CSB-1044-2
 Country : UK
 Date : 11/1/2006
 APC : E70
 Repair Level : 2

Title RAZR V3i - GSM - False Key Presses
 Model Effected V3i
PROBLEM

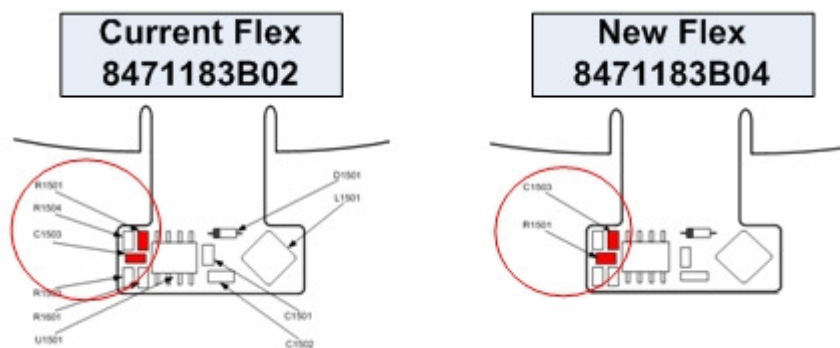
Service has been made aware of a V3i False Key Presses issue causing "Main Keypad - No function/ hangs" complaints; typical symptoms are SMS being sent but Send key not pressed, multiple characters when a key is pressed (6666 instead of just 6) and into call with out the Send key being pressed when flip is opened. Further analysis found that EL (Electro Luminance) noise could interfere with row 3 of the keypad and cause one or more keys to falsely pressed.

To improve the EL noise level the R1501 changed to 10K (part # 0613952R01) along with change of position for R1501 & C1503 K-Flex circuitry.
